APPLICATION NUMBER: 25/0909

PROPOSAL: TO VARY CONDITIONS OF 23/0418 CONSTRUCTION OF 5NO. FLATS, PARKING, LANDSCAPING AND ASSOCIATED WORKS

SITE: The Old Post Office 2 Tregarn Road Langstone Newport NP18 2JS

OBJECTION – INCONSISTENCIES AND INADEQUATE PLANTING TO SOFTEN VIEWS

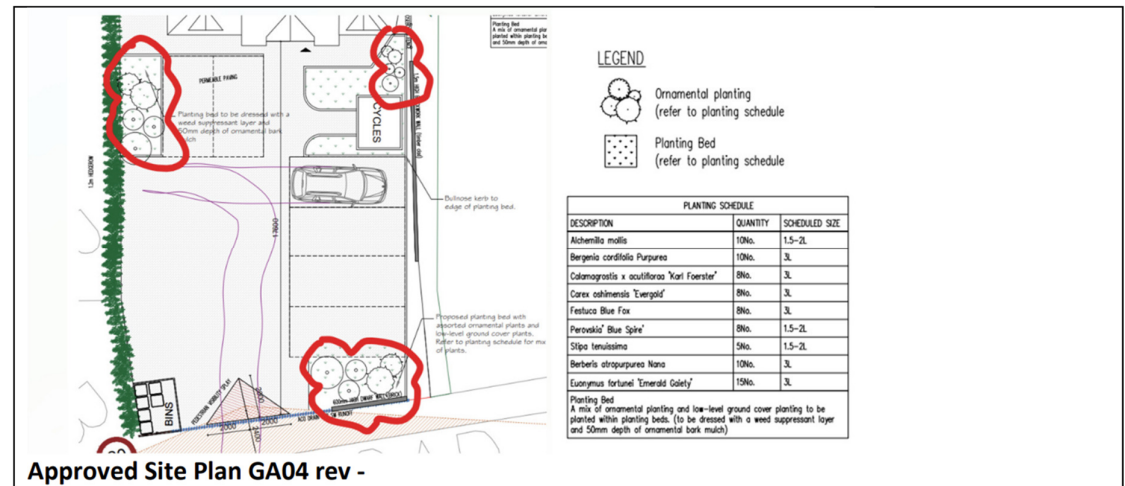
The approved site plan is below. The planting schedule was inadequate hence planting was conditioned.

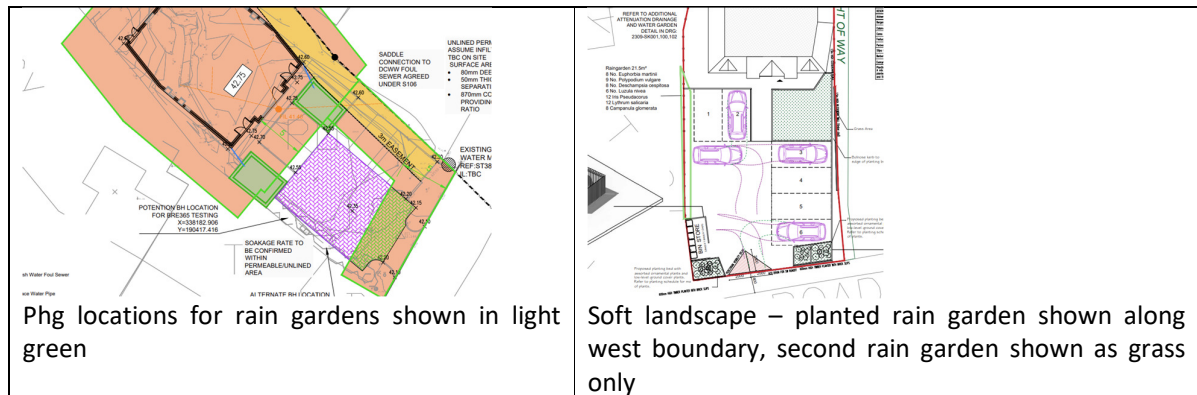
Planting has been reduced in scale to a rain garden (21.5sqm) on the west boundary (note this boundary is an evergreen hedge presumably outside this site) and ornamental planting beds within raised planters at the site frontage.

The timber planters (replacing a dwarf wall on the approved plan) will easily dry out, and rooting volume will be restricted, further limited by the continuous block paving under the planters. The solution is not typical of the suburban location or street scene. Converting to conventional planting beds, the size offers scope for specimen shrubs and small specimen trees with high evergreen year round interest ground cover at the site frontage but requires skilful planting design.

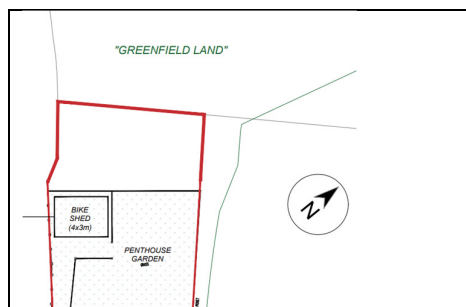
The SuDS plan by PHG shows rain garden in different locations. The rain garden areas need to be adequately planted, ie the current density is likely to be insufficient, and their locations and extents should reflect the PHG layout.
